Bucket Lip Review

Review of Whisler 10 Lip System at South American Mine Site.

*Review is based on field inspections of
P&H 2800 and P&H 4100 bucket lips.*

Publication #01.2004
January 2004

04.0110.04

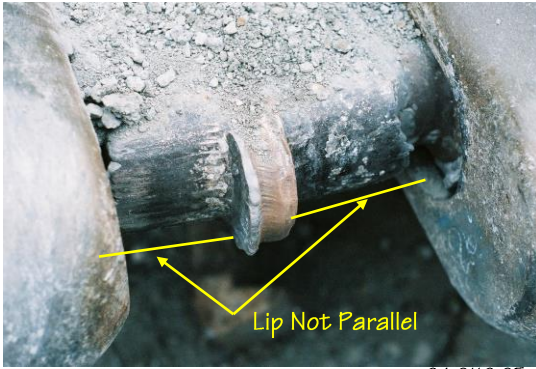
Lip location #1:
Stabilizer has broken off at the leading corner radii surfaces. The front radii do not seem to be perpendicular to the mounting hole. Flat bearing surfaces on the front have not been maintained to OEM specification. Bearing surfaces of the rear pad were not checked but show excessive material upsetting. In this condition adapter movement is of major concern.

Recommendation: Rebuilding of the lip position should be done prior to any testing.

04.0110.05

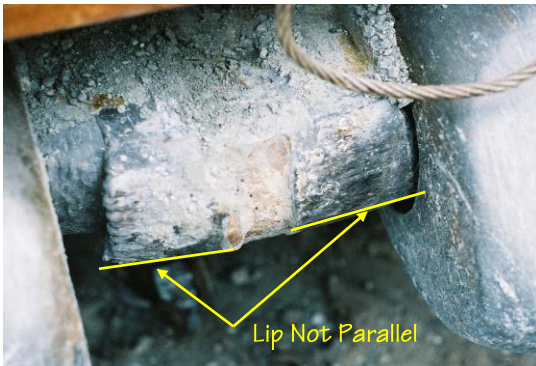
Lip location #2:

Stabilizer shows contact on both sides of the vertical walls indicating adapter movement in operation. The front radii are not parallel and will not allow a proper adapter connection. Flat bearing surfaces on the front have not been maintained to OEM specification. Bearing surfaces of the rear pad were not checked but show excessive material upsetting. In this condition adapter movement is of major concern.

Recommendation: Rebuilding of the lip position should be done prior to any testing.

04.0110.06

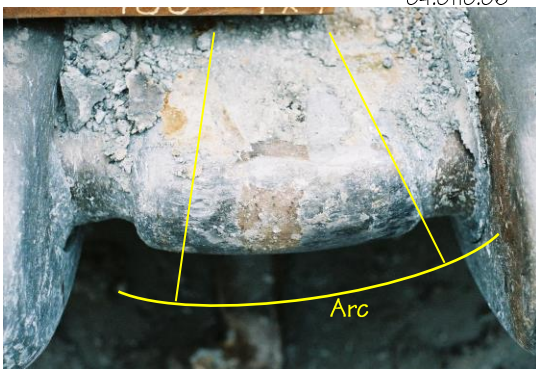
Lip location #3:

Stabilizer has broken off at the leading corner radii surfaces. The front radii are not perpendicular, improper adapter connection will be the result. Flat bearing surfaces on the front have not been maintained to OEM specification. Dirt fines remain intact at the stabilizer and radii-bearing surface indicating that there has been no contact at any time. Bearing surfaces of the rear pad were not checked but show excessive material upsetting. In this condition adapter movement is of major concern.

Recommendation: Rebuilding of the lip position should be done prior to any testing.

04.0110.07

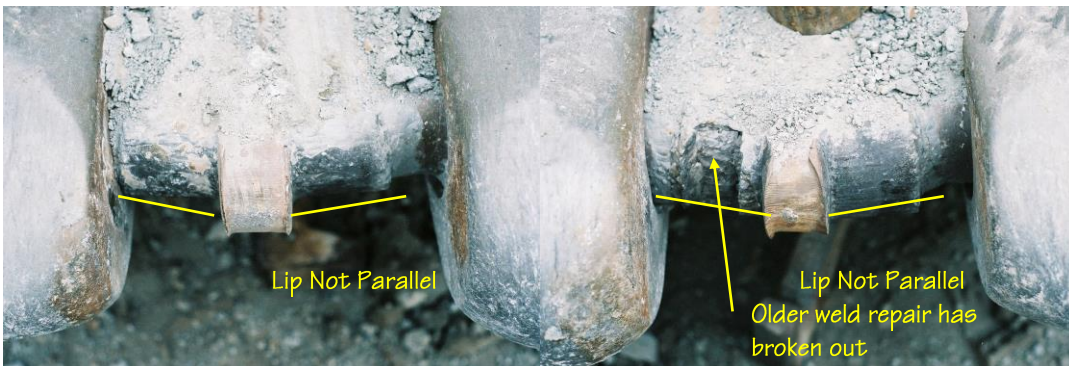
Lip location #4:

The front radii surface is completely rounded, adapter assembly pivoting from the key/clamp attachment has created lip arcing. Indication of an assembly problem can be seen in picture 04.0110.01 prior to removal of the Wh-10 Assembly. Dirt fines remain intact at the radii-bearing surface indicating very little contact between adapter and the lip.

Recommendation: Rebuilding of the lip position should be done prior to any testing.

04.0110.08

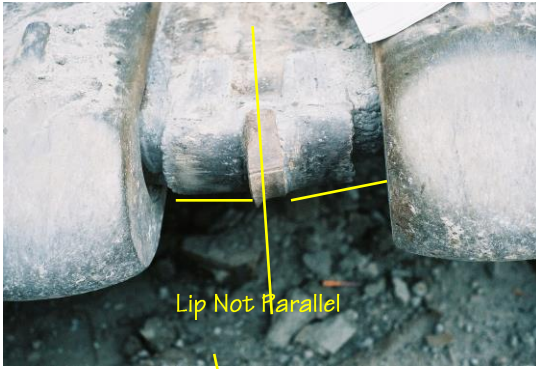
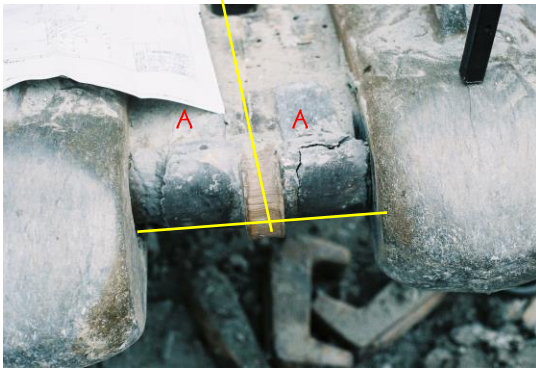
Lip location #5 and #6: Both stabilizers show contact on either sides. Position #6 has upset lip material on the vertical stabilizer wall indicating massive adapter movement in operation. The front radii are not parallel to each other. Flat bearing surfaces on the front have not been maintained to OEM specification. The rear bearing pads show signs of movement as all other adapter to lip locations.

Recommendation: Rebuilding of the lip position should be done prior to any testing.

04.0110.11

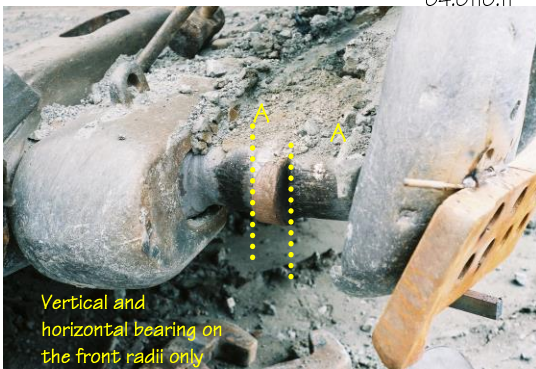
Lip location #7:

Stabilizer shows contact on both sides of the vertical walls indicating adapter movement in operation. The front radii are not parallel and will not allow a proper adapter connection. Flat bearing surfaces on the front have not been maintained to OEM specification. Flat bearing surfaces of the rear pad were not checked but show excessive material upsetting.

Recommendation: Rebuilding of the lip position should be done prior to any testing.

04.0110.35

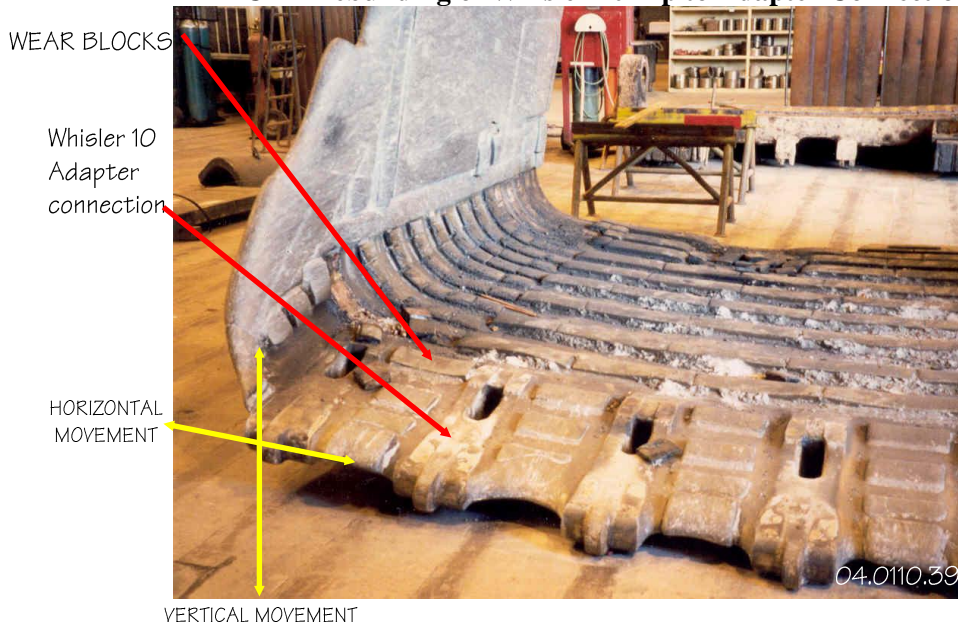
Lip thickness was larger than the maximum allowed by P&H print. This new lip requires grinding prior to placement.

Note the perpendicular alignment between the stabilizer/mounting hole and the radii surface on each side of the stabilizer. THIS IS A GOOD ALIGNMENT.

Further evidence that the OEM has not offered additional maintenance rebuild information is mine maintenance personnel had purchased a new spare P&H 2800-bucket lip for installation. When we checked this new lip to the factory requirement (X-2562-N Gauging) we found that the flat bearing surfaces were all over the maximum allowable tolerance that all manufacturers specify, including P&H (reference P&H gauge drawings G-55639 and G-55766 from 1975).
